CONSTRUCTION MANAGER'S CLARIFICATION NUMBER ONE (1)

DATE: MARCH 15, 2019

RE: LUMPKIN COUNTY LIBRARY

MEDIUM DUTY ASPHALT PAVING

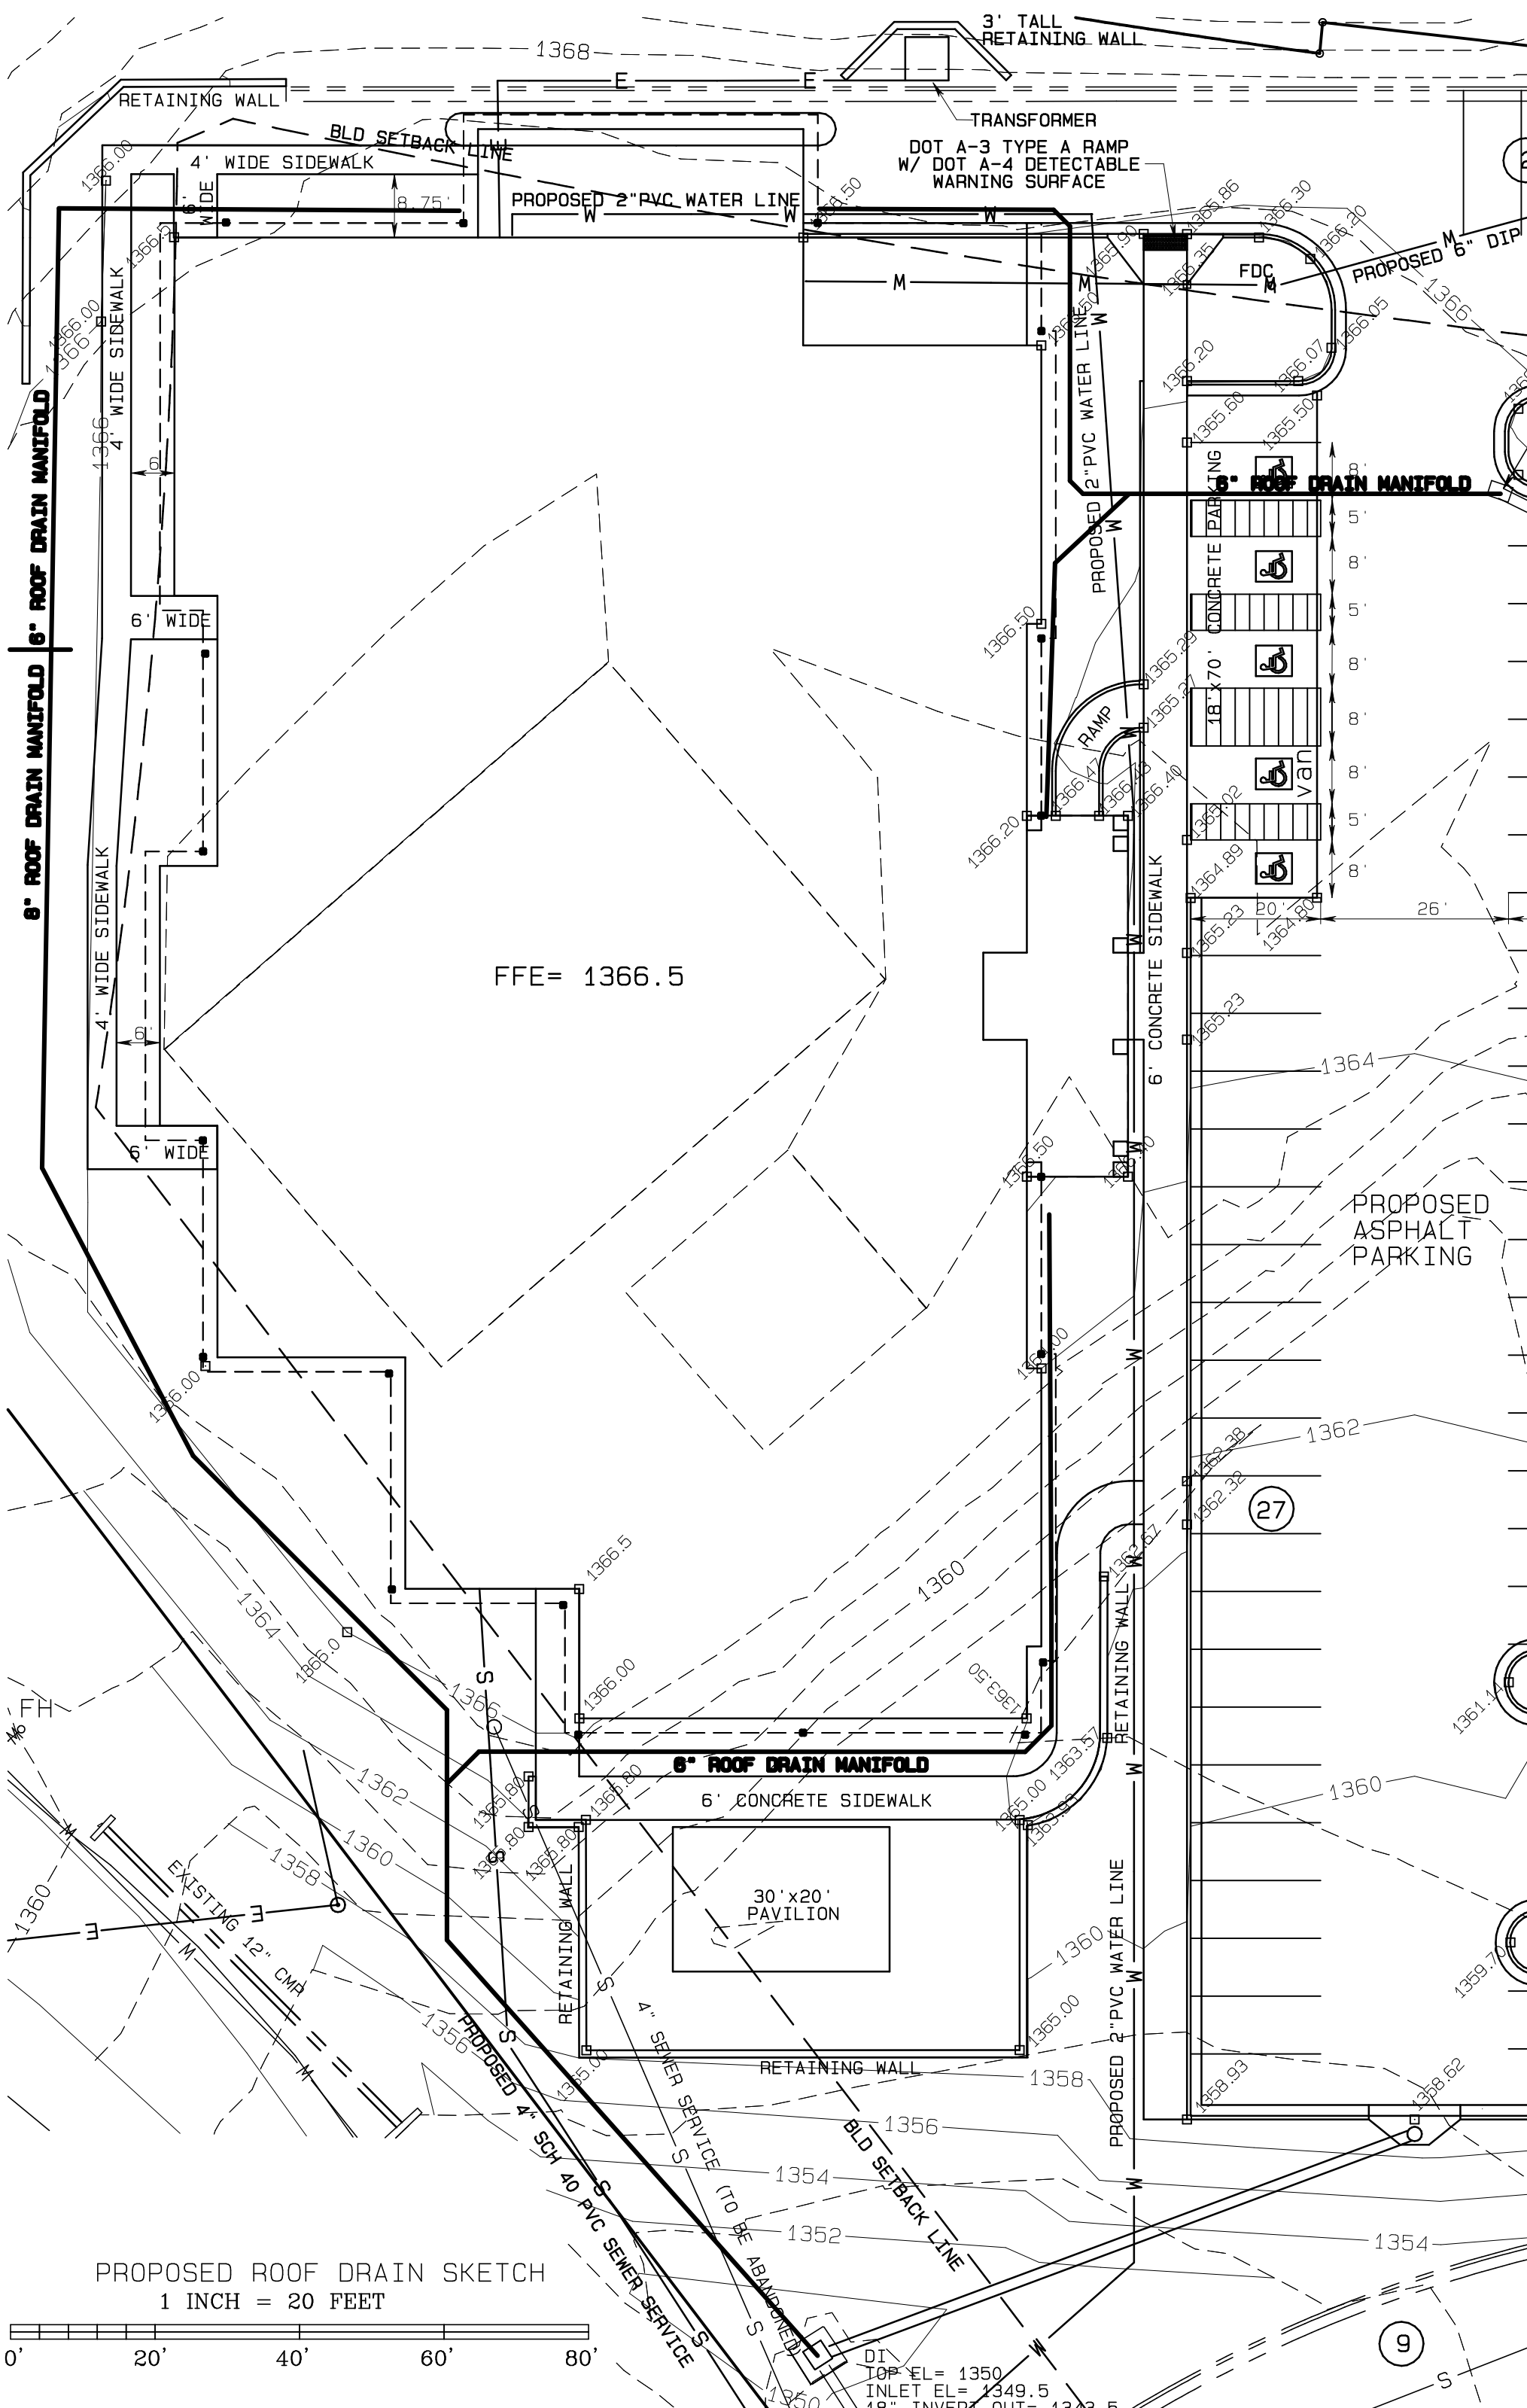
- Please see the attached Paving detail. This will be the paving specifications used in this bid package.

Base and binder to be installed at the Construction Manger's direction prior to building construction.
